**Subject: Vermont Yankee Nuclear Power Station
License No. DPR-28 (Docket No. 50-271)
Technical Specifications Proposed Change No. 258
RPV Fracture Toughness and Material Surveillance Requirements**

Proposed Technical Specification Change No. 258

RPV Fracture Toughness and Material Surveillance Requirements

Calculation Summary Report for Revised P-T Curves

Figure 4: Core Not Critical P-T Curve (Curve B)

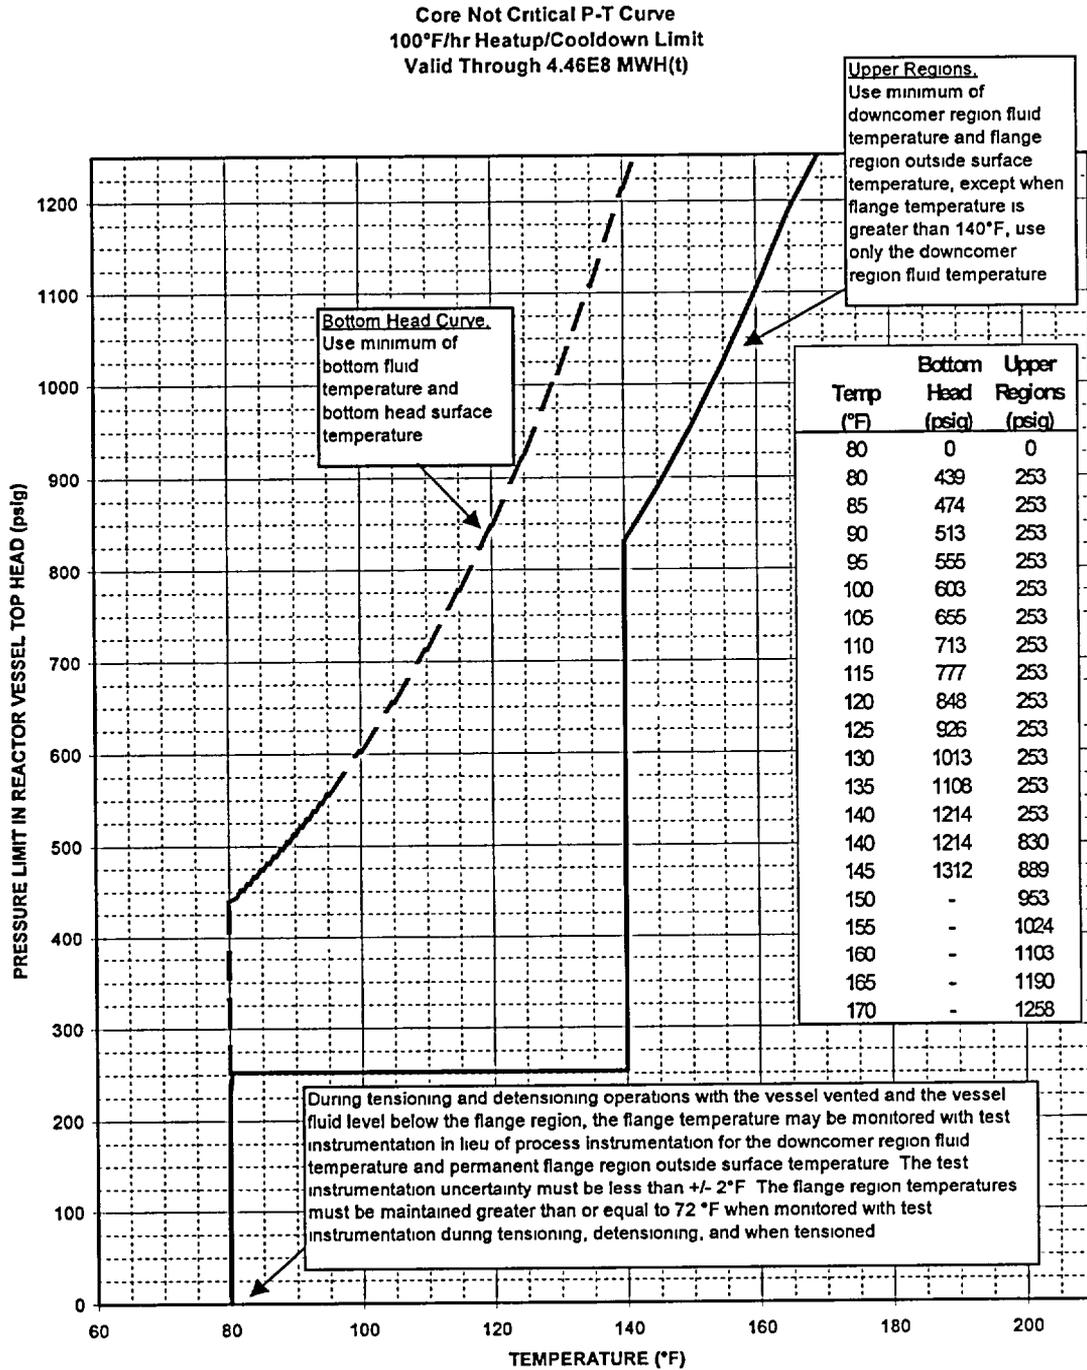
Therefore when monitoring external flange temperature with local test instrumentation during tensioning and detensioning the flange region temperatures must be maintained greater than or equal to 72 °F. A note has been added to the P-T curve in Figure 4 to specify this requirement.

VYNPS
FIGURE 3.6.1

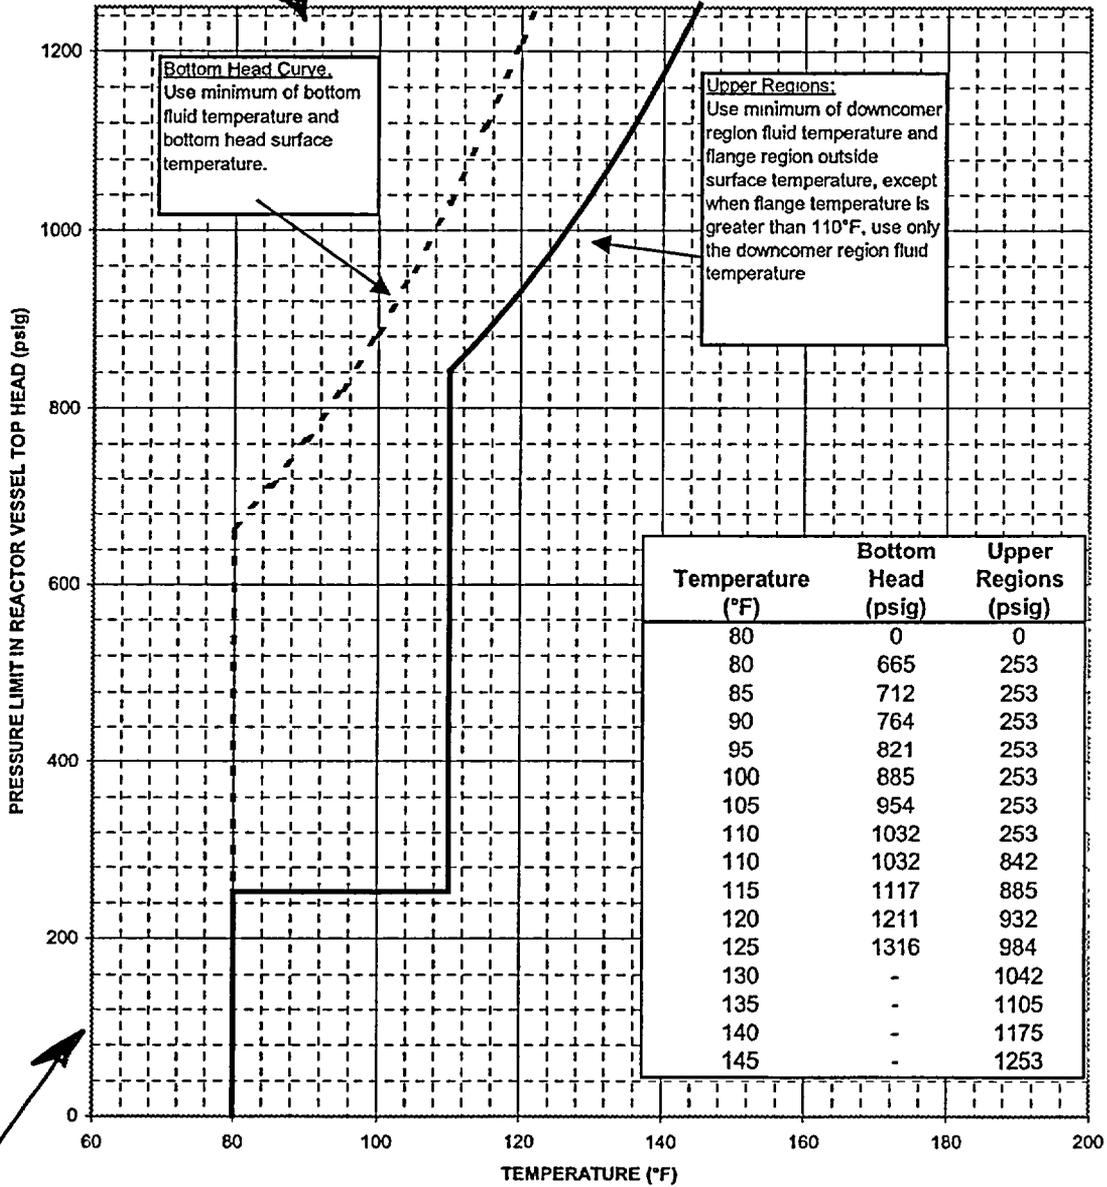
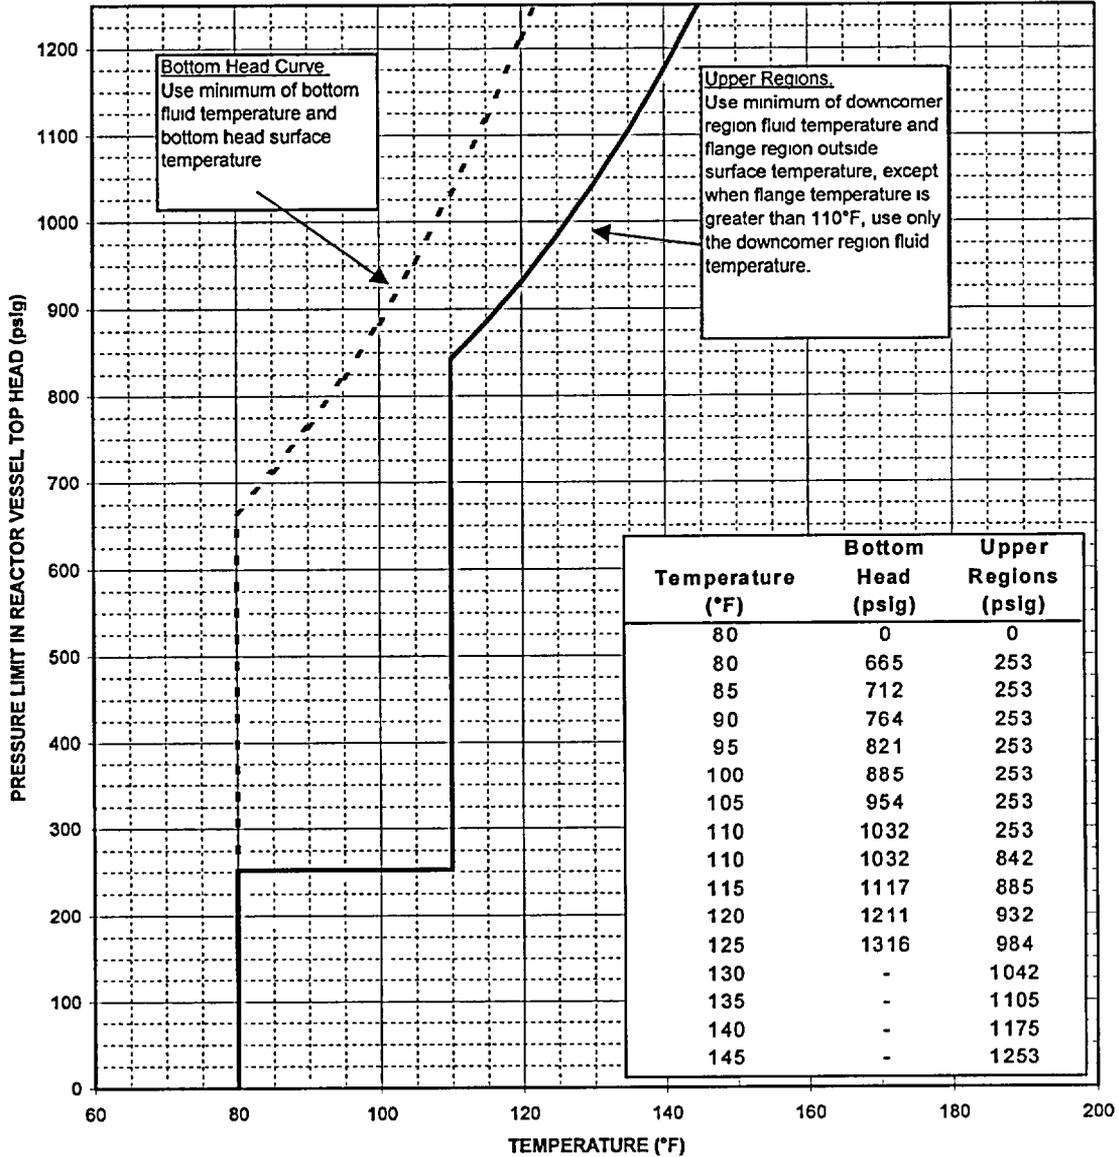
- Figures 3.6.1, 3.6.2 and 3.6.3 currently contain a statement that each is valid through the end of Cycle 23. That validity duration is being changed to 4.46×10^8 megawatt-hours thermal (MWH(t)).
- To improve legibility of the curves, the grid line divisions have been changed, the ordinate axis has been identified by 100 psi increments, and more data were used to plot the curves to improve resolution.
- A Note is being added to TS Figure 3.6.2 to specify requirements for minimum temperature when using local test instrumentation during flange tensioning and detensioning operations. The new Note will specify:

The change to TS Figures 3.6.1, 3.6.2 and 3.6.3 to extend their applicability to 4.46×10^8 MWH(t) corresponds to an integrated plant operation of 32 EFPY. This limitation is acceptable because it is based on the re-calculated, expected neutron fluence over 40 years of operation at the current licensed power level, accounting for periods of downtime.

CHANGE GRID LING DIVISIONS AND USE MORE DATA TO PLOT CURVES

40°F/hr Heatup/Cooldown Limit
Valid Through 4.46E8 MWH(t)

FIGURE 3.6.2

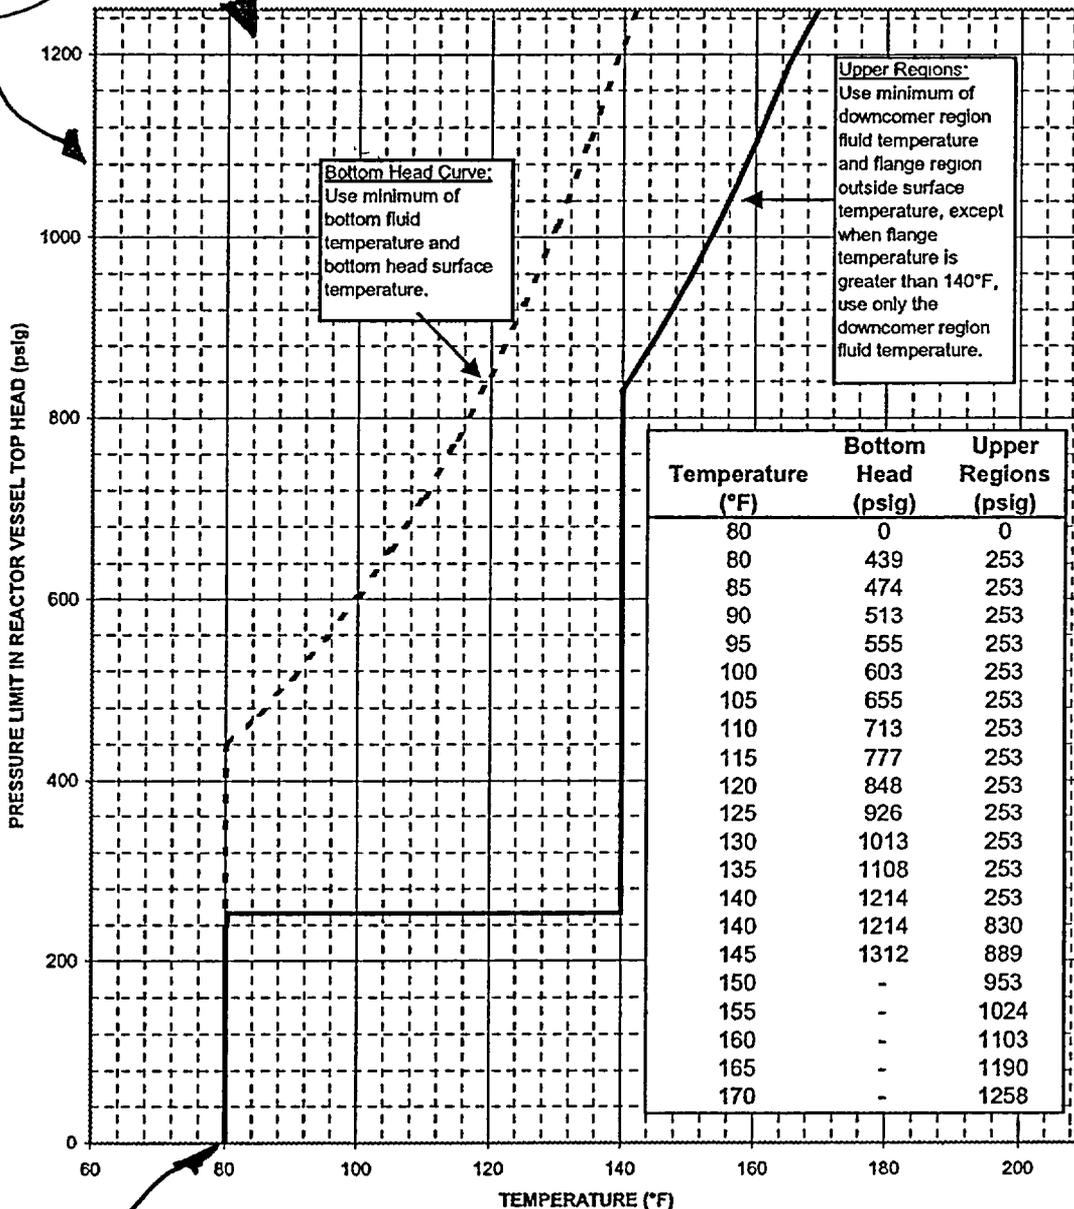
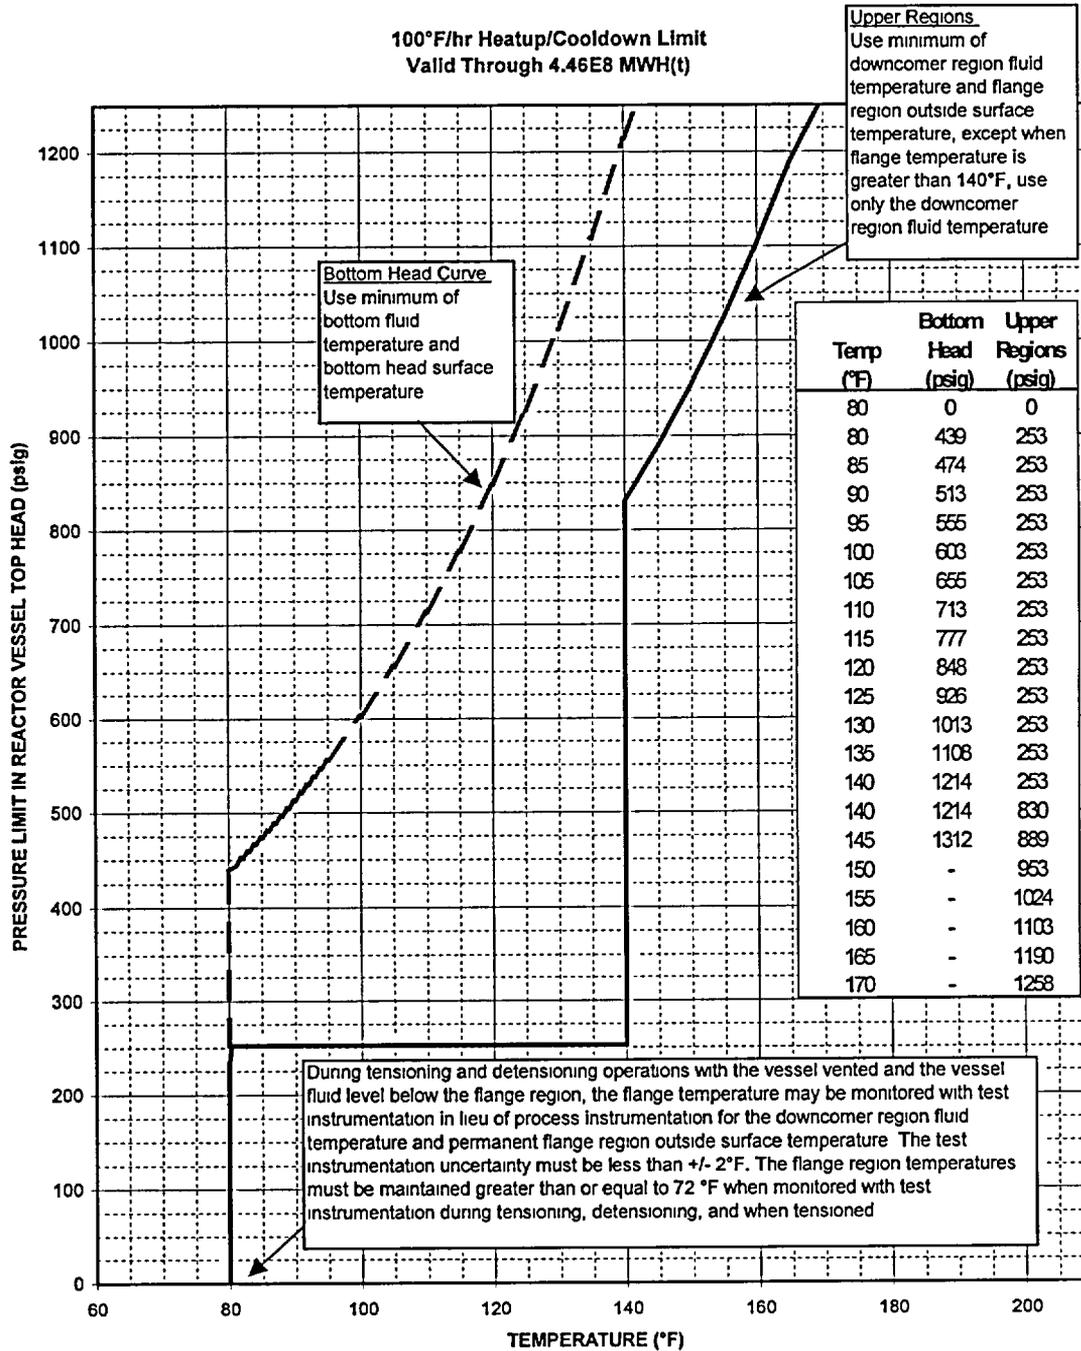
The addition of a Note to TS Figure 3.6.2 to permit use of test instrumentation during tensioning, detensioning, and when tensioned is acceptable because test instrumentation can provide a better method of monitoring bolt-up temperatures during this phase of operations. The use of such instrumentation is limited to the condition when the vessel is vented and vessel fluid level is below the flange region. The establishment of this condition ensures that the vessel cannot be pressurized while relying on test instrumentation. Because test instrumentation is more accurate (conservatively within +/- 2°F) than permanent temperature instrumentation (+/- 10°F), a limit of $\geq 72^\circ\text{F}$ may be established when using test instrumentation. A 72°F limit for test instrumentation corresponds to an 80°F limit for permanent temperature instrumentation when the respective instrumentation uncertainties are included. These values are acceptable because the analytical limit for head bolt-up is 70°F (without instrument uncertainty) as stated in current TS 3.6.A.

A Note is included in Figure 3.6.2 that specifies test instrumentation uncertainty must be +/- 2°F and the flange region temperatures must be maintained greater than or equal to 72°F when using such instrumentation in lieu of permanently installed instrumentation. Qualified test instrumentation may only be used for the purpose of maintaining the temperature limit when the vessel is vented and the fluid level is below the flange region. If permanently installed instrumentation (with a 10°F uncertainty) is used during head tensioning and detensioning operations, the 80°F limit must be met.

4.46 EB MWH(ε)

SHOW 100 PSIG INCREMENTS ON ORDINATE AXIS

100°F/hr Heatup/Cooldown Limit
Valid Through 4.46E8 MWH(t)

FIGURE 3.6.3

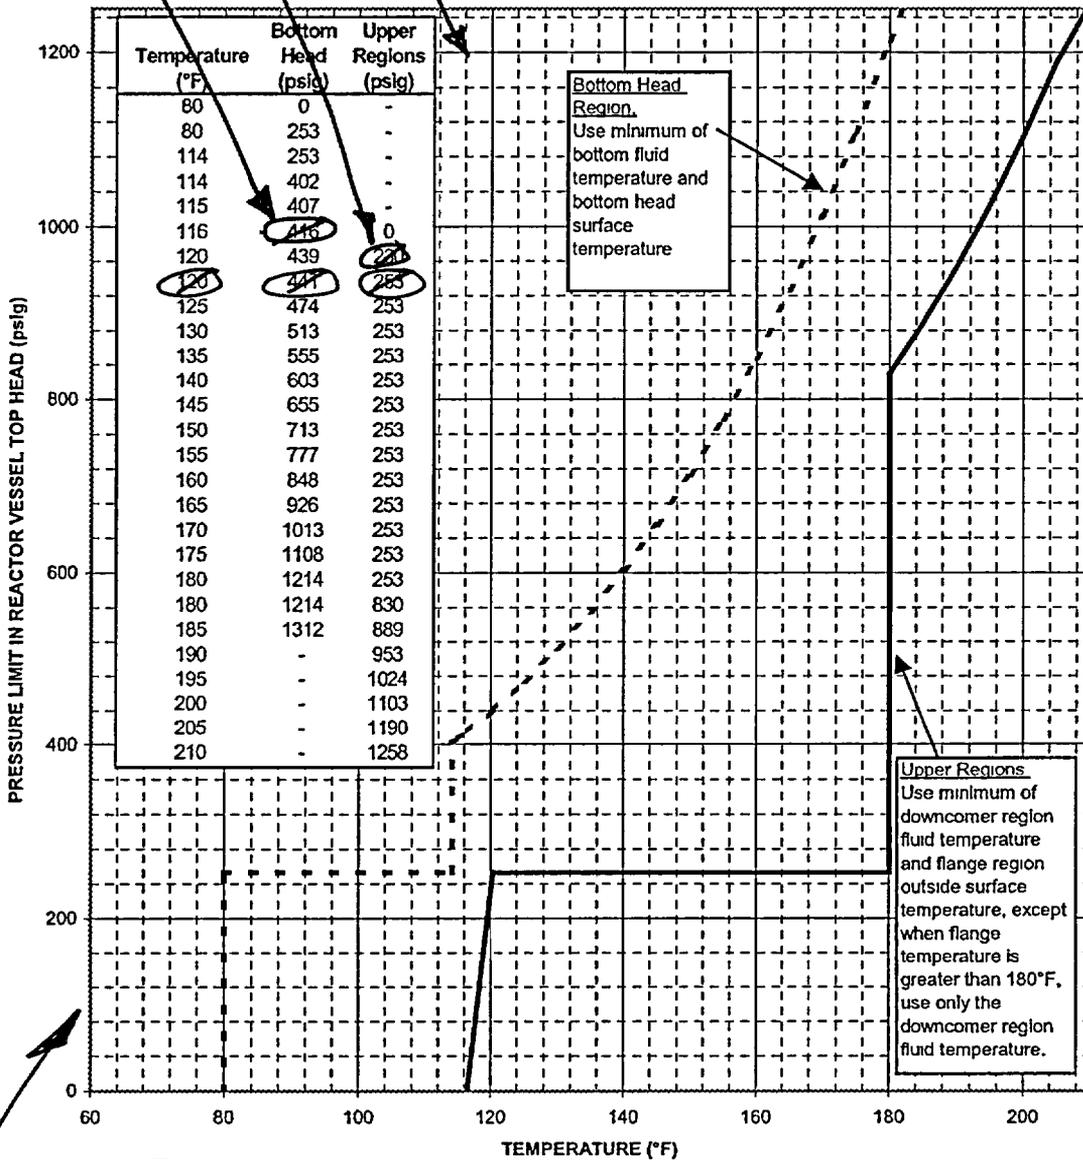
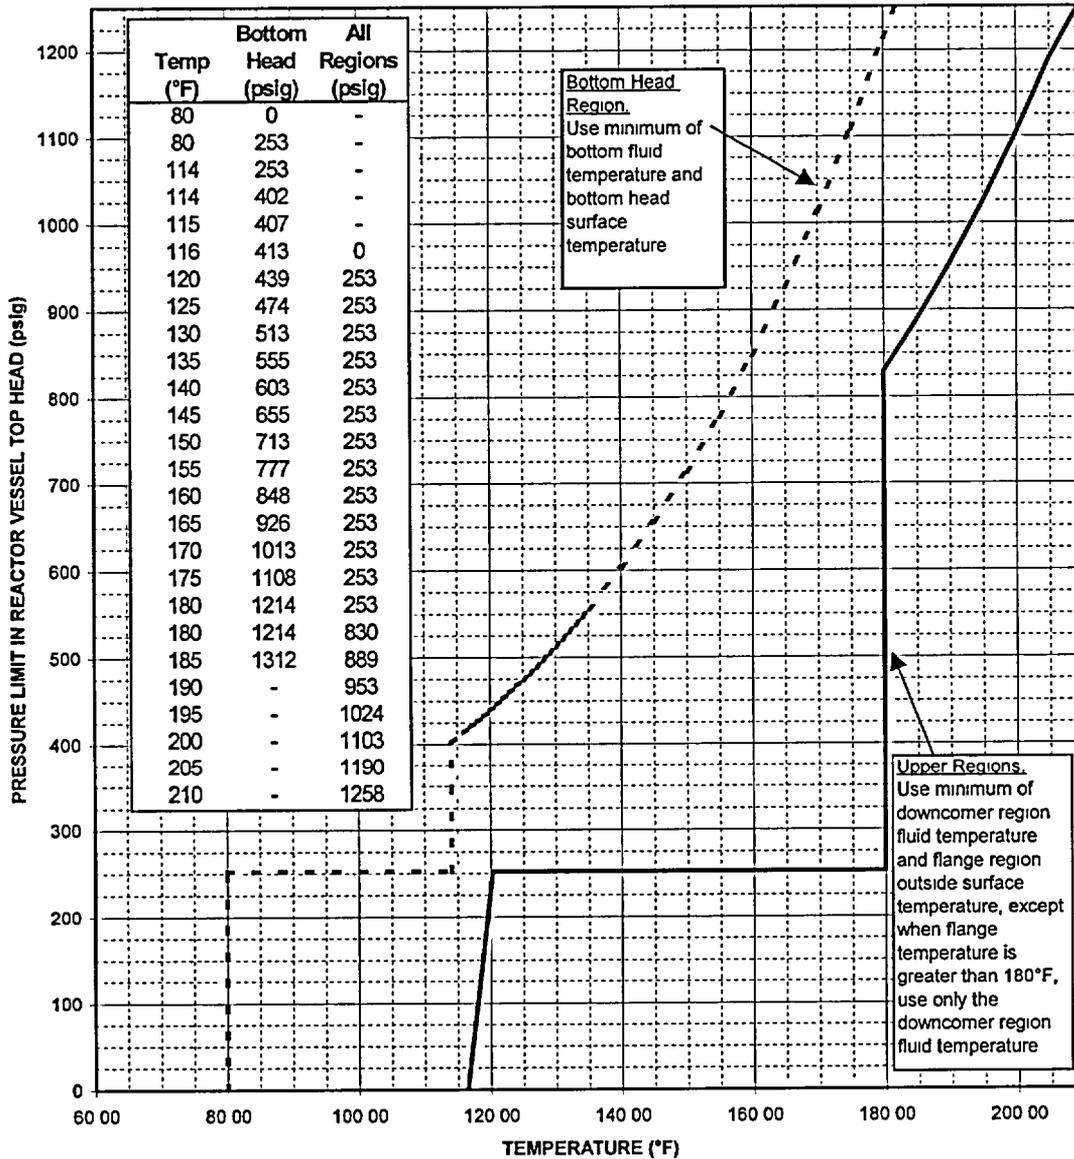
- The tabulation of pressure and temperature data on Figure 3.6.3 is being revised to more accurately reflect the plot of the curves (the curves are unchanged). At 116°F the bottom head pressure is changed to 413 psig, instead of the current 416 psig. At 120°F, there should be only two data points on Figure 3.6.3, and these are at 253 psig for the upper region and at 439 psig for the bottom head region. Therefore, the tabulation corresponding to a temperature of 120°F will only specify pressures of 439 psig and 253 psig for the bottom head region and upper region, respectively.

The changes to the tabulation in Figure 3.6.3 represent a correction of actual values used to generate the current curves. The current tabulation indicates that four different pressure limits were established corresponding to a temperature of 120°F. As can be seen from the curves, there are only two such points for 120°F. Similarly, the change in bottom head pressure at 116°F to 413 psig reflects a past administrative error in transcribing the actual value from the current curve. These changes to correct the tabulation are acceptable because they do not change actual limits (the curves are unchanged) and reflect the outputs from previous analyses.

4.46 EB MWH(E)

SHOW 100 PSE INCREMENTS ON ORDINATE AXIS

100°F/hr Heatup/Cooldown Limit
If Pressure < 253 psig, Water Level must be within
Normal Range for Power Operation
Valid Through 4.46E8 MWH(t)
